Salt Lake County Planning Commission

29130 – Scott Carlson – Requesting preliminary plat approval for the Silver Hill Lodge 4-lot Subdivision. **Location:** 11340 East Church Road. **Zone:** FR-0.5 (Foothills Recreational) and Foothills and Canyons Overlay Zone (FCOZ). **Planner:** Todd A. Draper

STAFF REPORT

Executive Summary									
Hearing Body:	Salt Lake County Planning Commission								
Meeting Date and Time:	Wednesday, January 14, 2015	08:30 AM	File No:	2	9	1	3	0	
Applicant Name:	Scott Carlson	Request:	Subdivision						
Description:	Silver Hill Lodge Subdivision 4-lot								
Location:	11340 E. Church Road								
Zone:	FR-0.5 Forestry & Recreation	Any Zoning Conditions?	Yes <input type="checkbox"/>	No <input checked="" type="checkbox"/>					
Staff Recommendation:	Approval with Conditions								
Planner:	Todd A. Draper

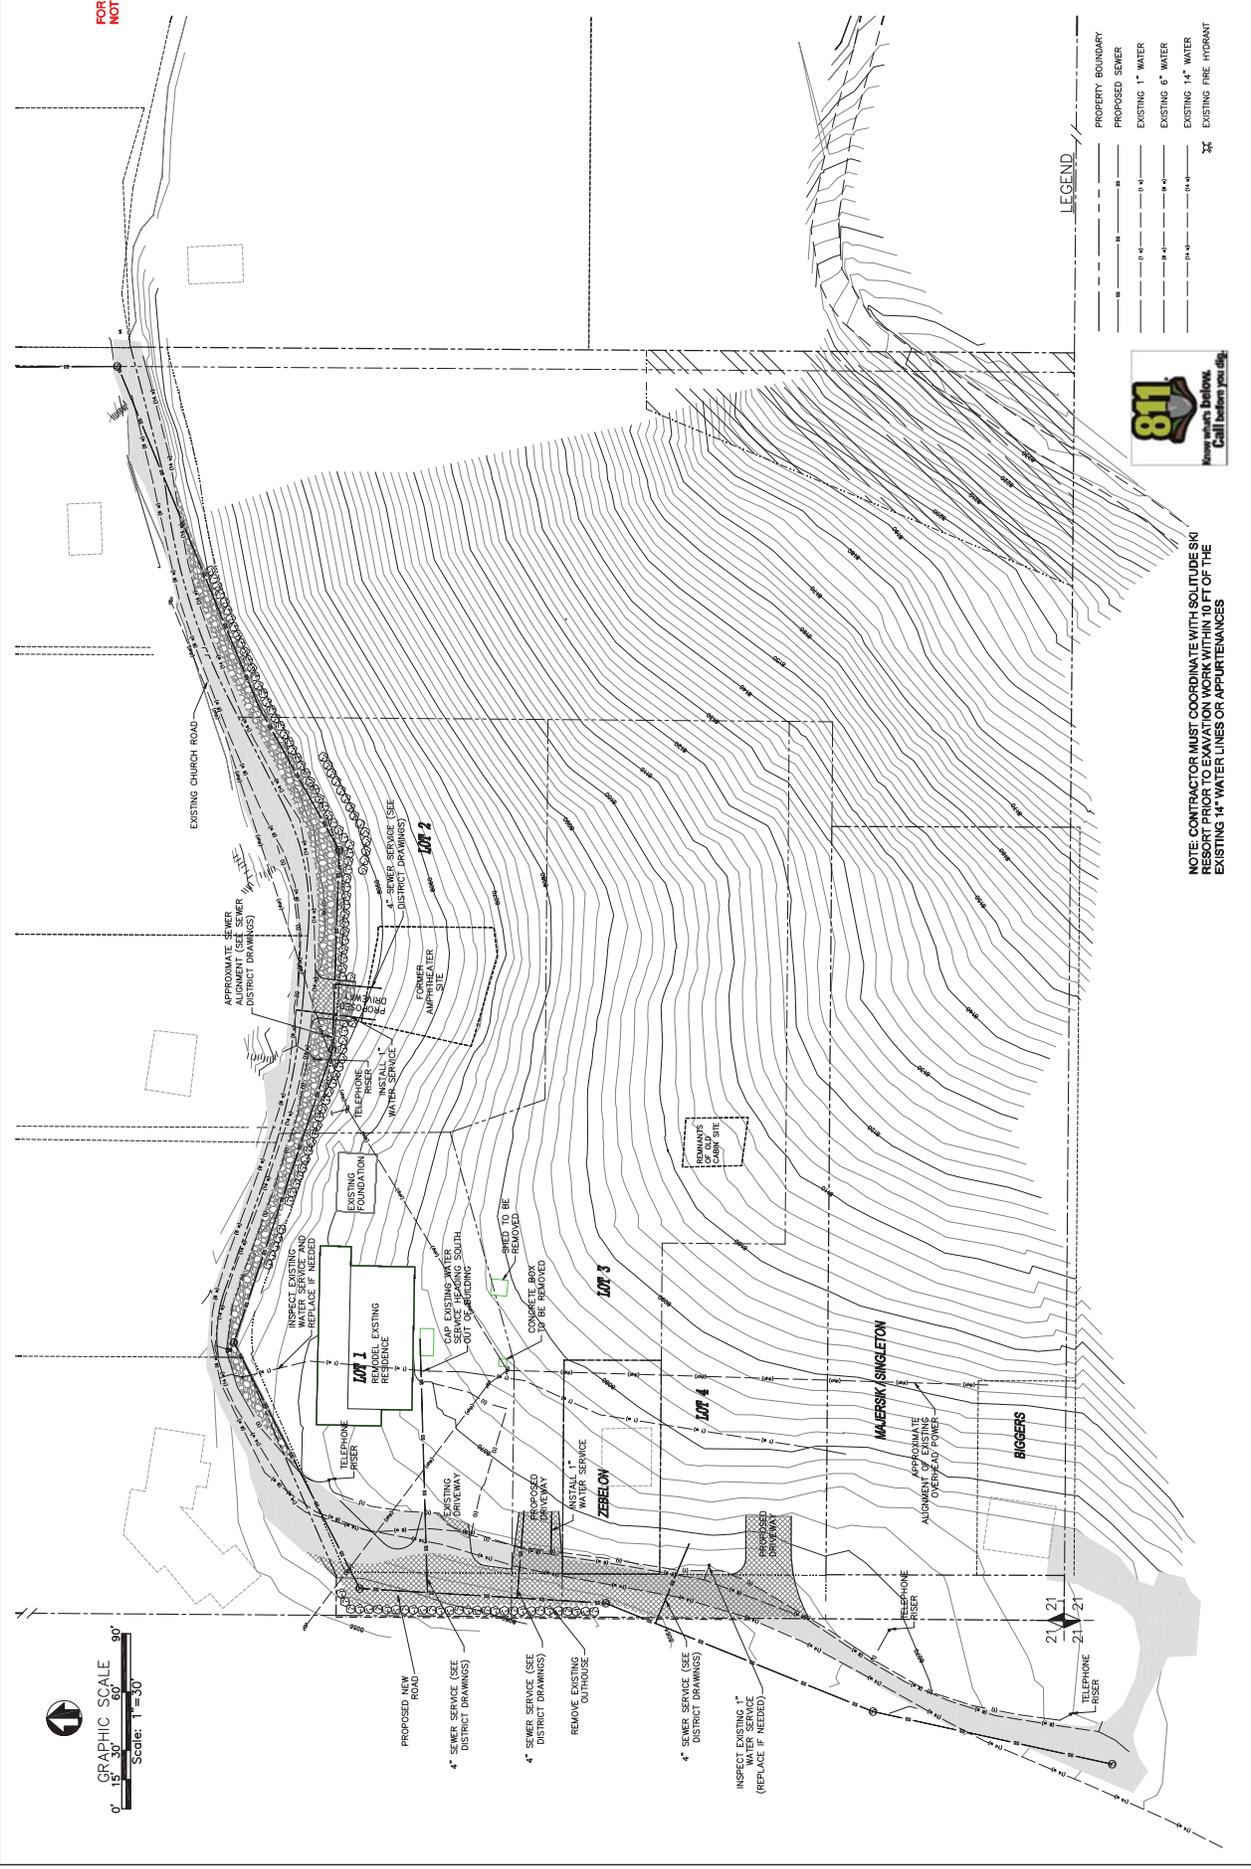
3. Plat and plans must show how lots 3 & 4 are accessed. If there is road it must be shown on plat with its name.

4. Must show Fire Hydrants on plat.
5. All Streets within 200 ft. of the proposed subdivision must be shown on plat.
6. Label all utility and drainage easements on the plat
7. A preliminary report of title will be required at the final stage of the project.

3. The manmade slope at lot # 2 is in excess 10'feet high and will create issues with the proposed access location based on the required depth of the driveway and location of the buildable area, with the retaining sections of FCOZ as well as the grade change restrictions.

5. The proposed Terraced Rock walls need to be terraced from the back of the lower wall to the face of the upper wall (not face of lower wall to face of upper wall to create five foot terrace as shown in details)

6. Need to provide Top and Bottom elevations of the proposed walls.
7. Need to provide a slope stability analysis on the proposed rock faced slopes for the main access to the subdivision.

8. Need to provide written approval from Traffic and UFA on placing gravel over the Road based instead of asphalt, since the road is main access.
9. The proposed location of the Silt fencing is located in the Centerline of the existing road bed which will prevent existing cabin owners access during construction and beyond, until re-vegetation is established.

10. Need to identify the locations of the planned 2:1 slopes on the drawings which are noted in the general notes and show both toe and catch points.
11. Need to show how the Stormwater will be directed off the roadway and controlled in a manner not to create additional Erosion.

(Note-- Driveway to Lot # 2 should be through lot # 3 easement and not off the main road, as planned)

Must provide the engineering specifications for the driveway on lot # 2.

1. The slopes on lot #2 are steep with 25% to 50% varying slopes. Must provide buildable area limits for this lot.
2. Plans do not show how water and snow will be kept off of the main Church Road for lots 1,3 and 4. There is a concern for the safety of drivers.
3. Provide a cross section of the rock wall along lots 1 and 2.
4. Grading and Drainage plans must include the name and phone number of the registered professional engineer. P.E. stamp is required and must be signed and dated.
5. Plans must include the project name, address, north arrow and scale (minimum 1 inch = 20 feet).

Each lot in FCOZ is required to delineate the location of a building pad/buildable area on the lot per 18.12.010 (4)(b) and 18.20.025 (C). The building pad must be fully located on slopes less than 30%.

Utilities lines are required to be buried as part of this subdivision application. This will include the existing lines that service the property as well as the new service lines. This is especially pertinent to the existing overhead power lines on the property. Appropriate easements must also be included and shown on the subdivisions plats.

1. plat must include plat revision blocks and the date of preparation.
2. The address of the subdivision must be included in the subdivision title.
